DOE/EIS - 0138  
Volume IV, Appendices 1, 4, 6, 9, 10, 12-16  
Errata and Revisions

**SUPERCONDUCTING  
SUPER COLLIDER**

**Appendices 1, 4, 6, 9, 10, 12-16  
Errata and Revisions**

**December 1988**

Figure 1.2.4-1  
 MICHIGAN SITE MAP

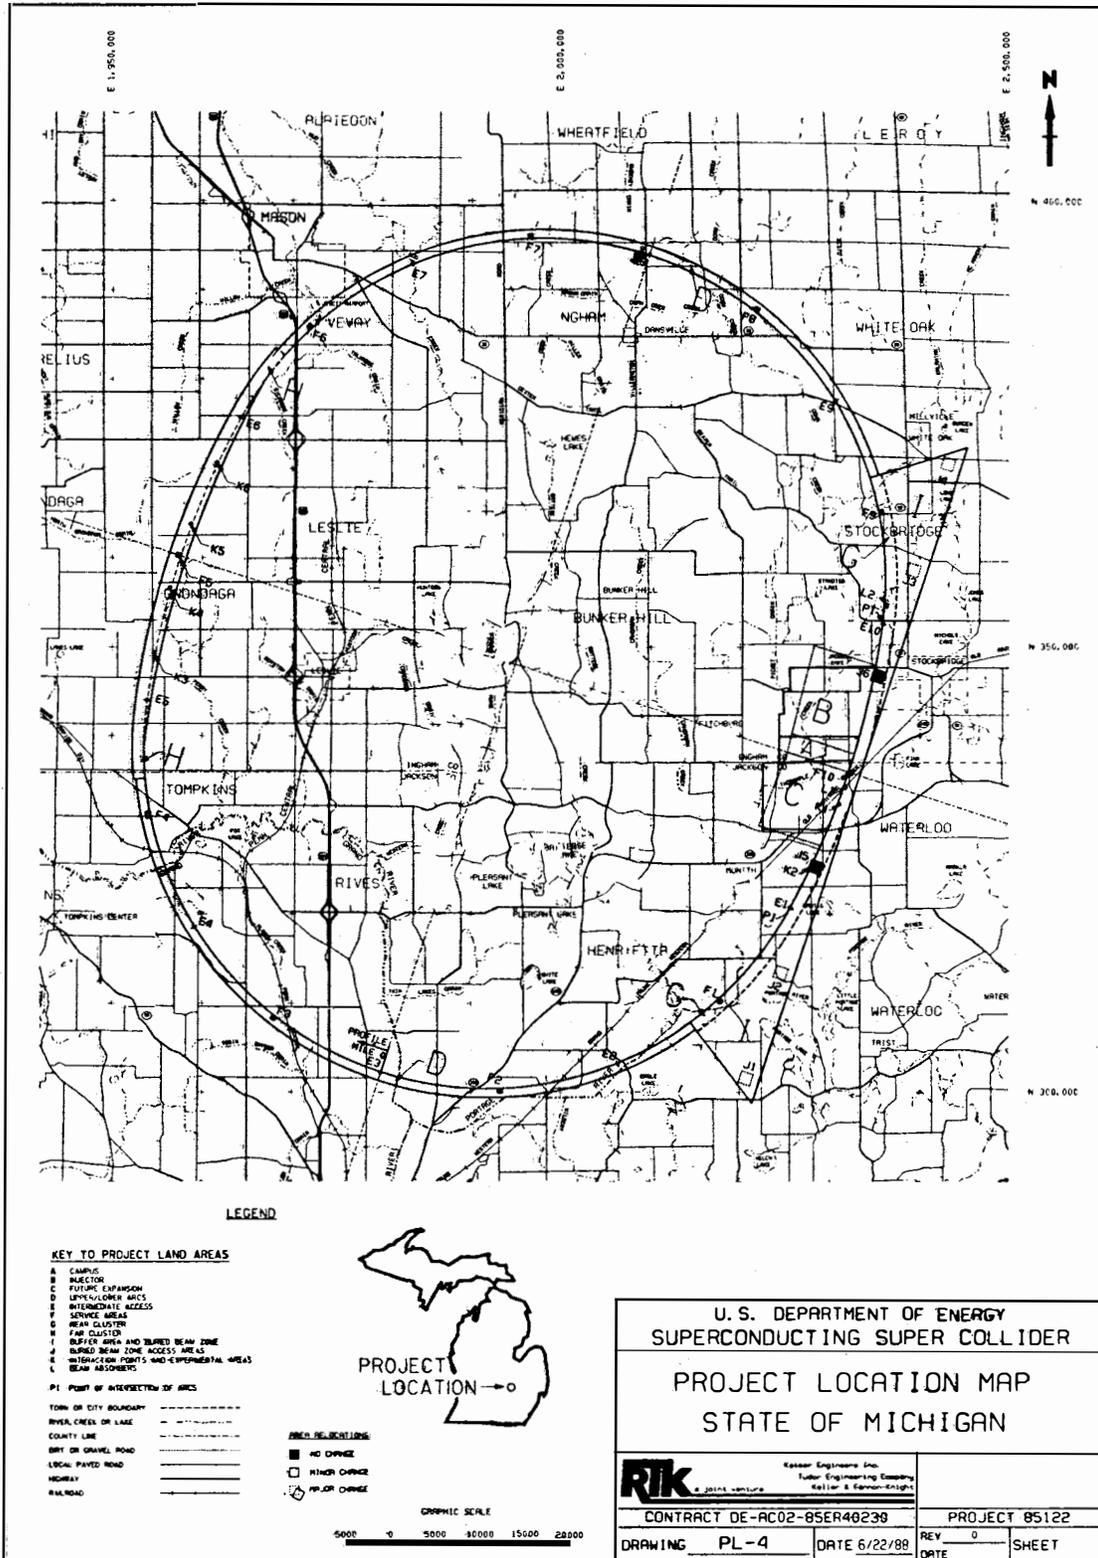
- Page 38: Figure 1.2.4-1, upper peninsula of Michigan was omitted from drawing insert at bottom. While drawing was intended to denote only contiguous area of the state, for comparability with other state maps, upper peninsula was added

Figure 9-32

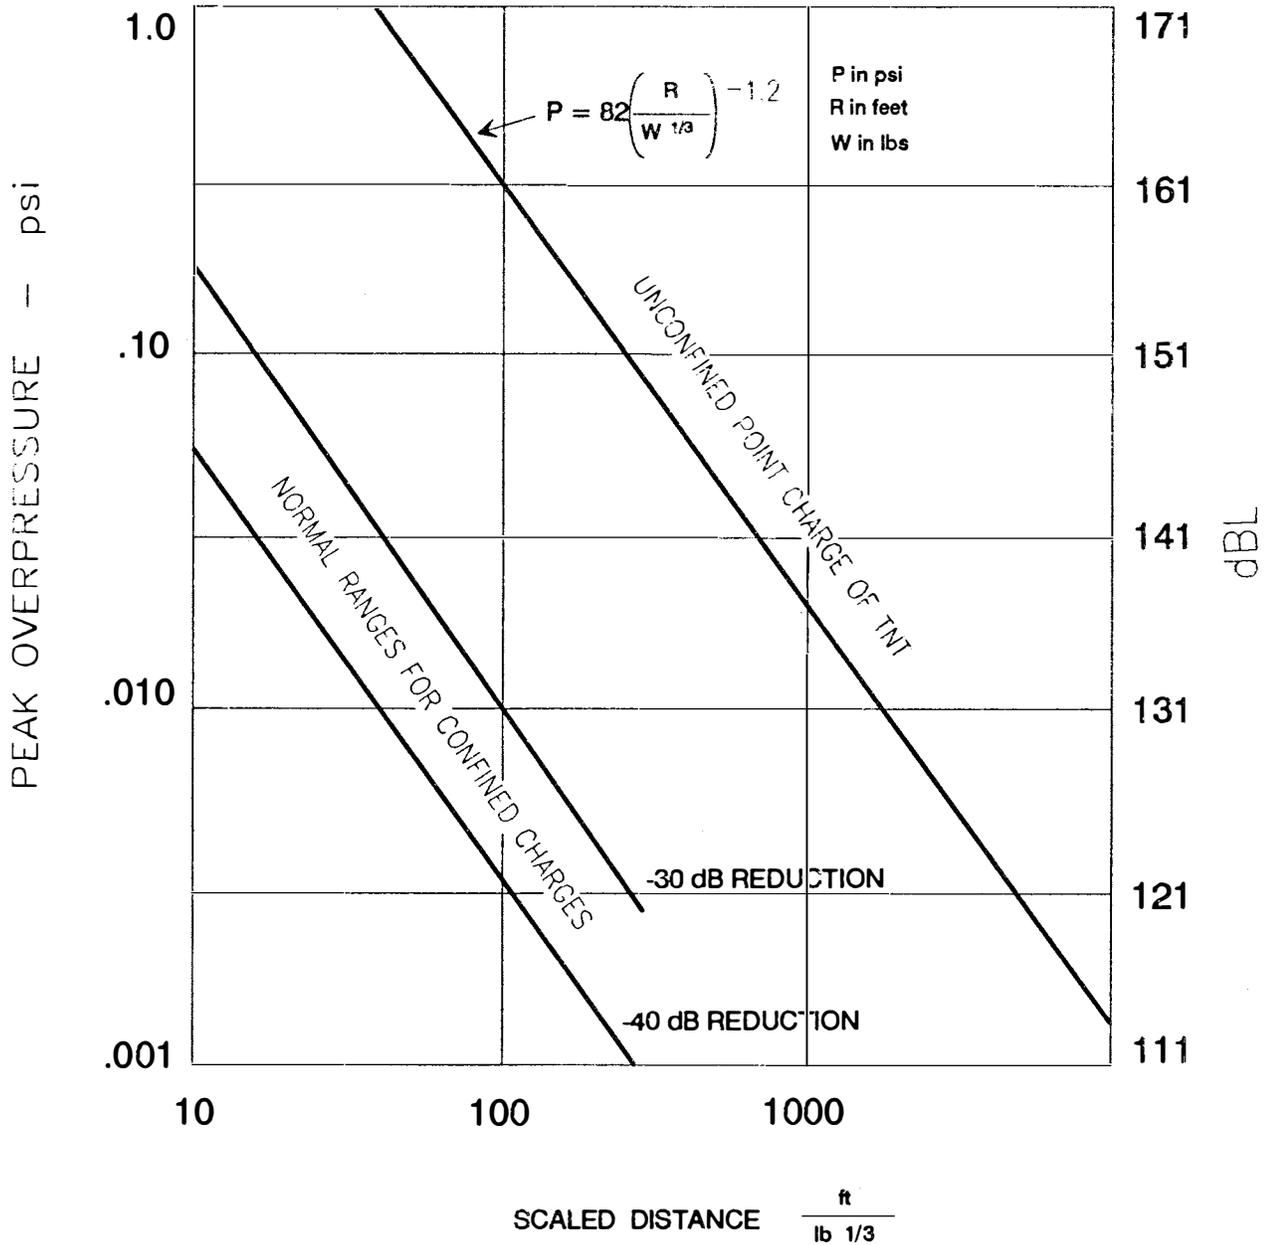
<u>Figure</u>	<u>Title</u>	<u>DEIS Page</u>	<u>Page</u>
9-32	Charge-Weight-Per-Delay Values	80	1

Figure 14.1.1.3.4-5

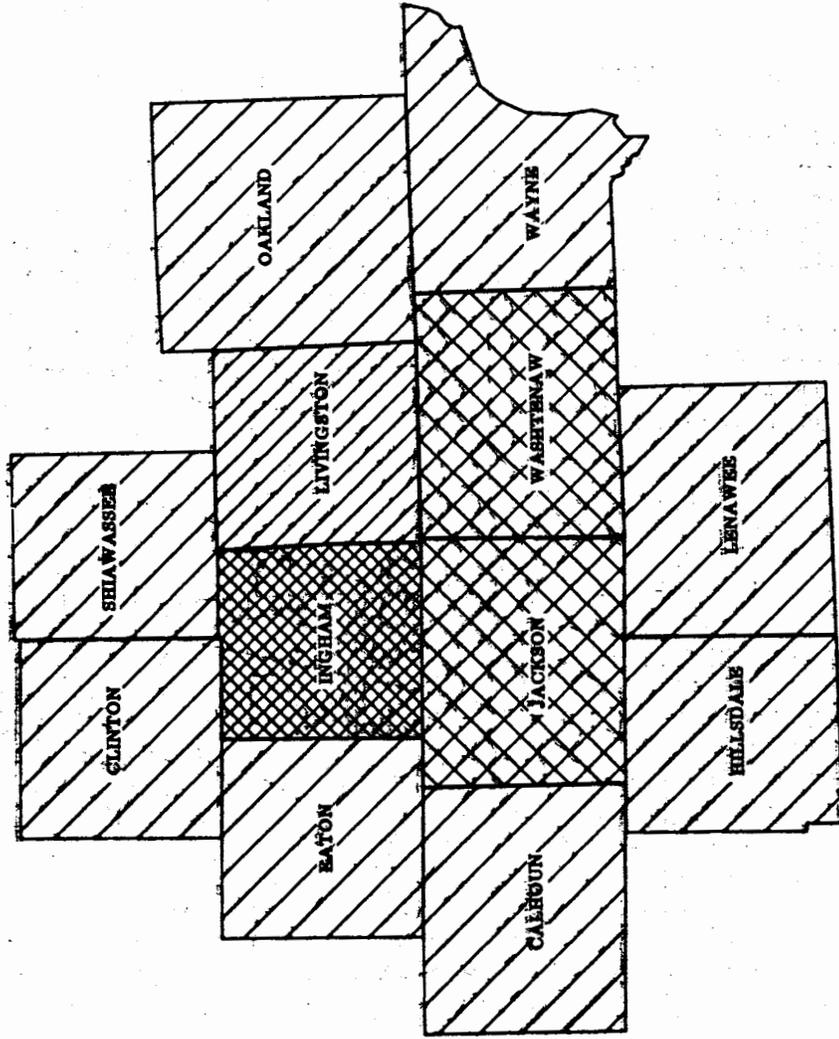
- Page 148: Figure 14.1.3.4-5, Clinton County has incorrect fill pattern. See attached.
- Page 149: Par. 1, Lines 3 and 4 should read: would reside in Ingham County. Although this single-year impact ...  
Par. 2, Line 5, reference should read: ... 1982c  
Par. 2, Line 9, reference should read: ... 1987b)  
Par. 4, Line 4, reference should read: ... 1982e  
Par. 4, Line 8, reference should read: ... 1987b)

Figure 14.2.1-8

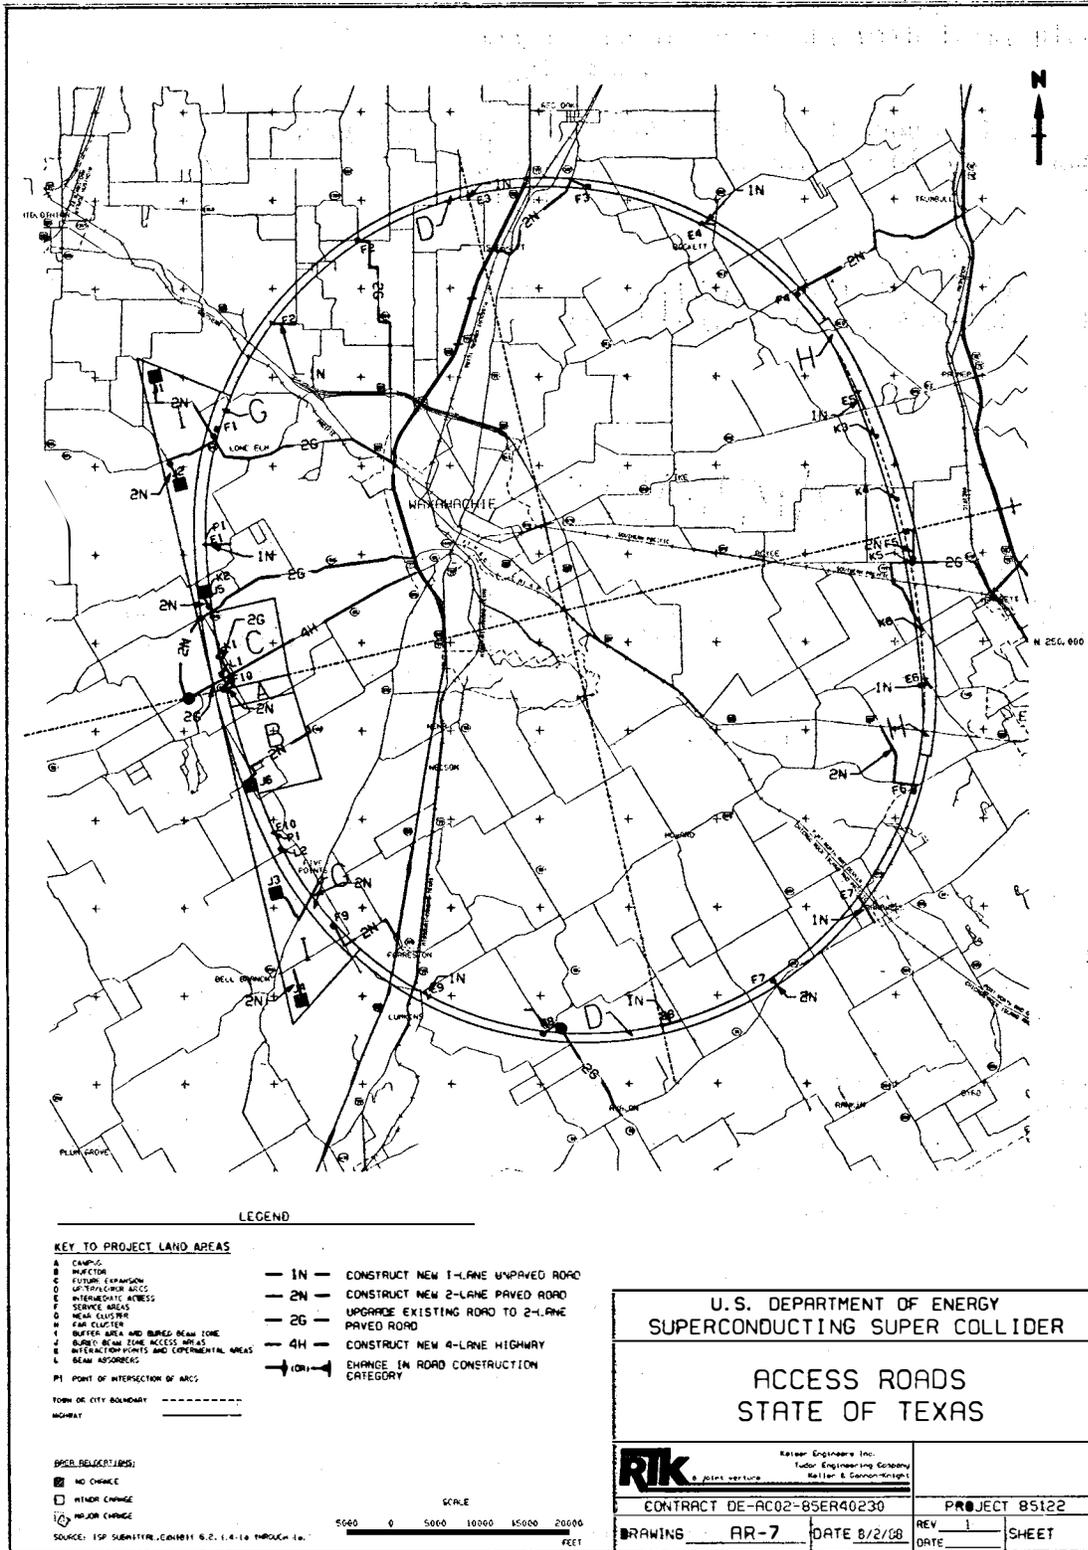
Same paragraph, Line 5 should read: Route 71 from Woodrow to Last Chance would experience ...
- Page 32:** Figure 14.2.1-4, Legend, first item in right column should read: Construct New 1-Lane Paved Road
- Page 33:** Par. 3 should read:
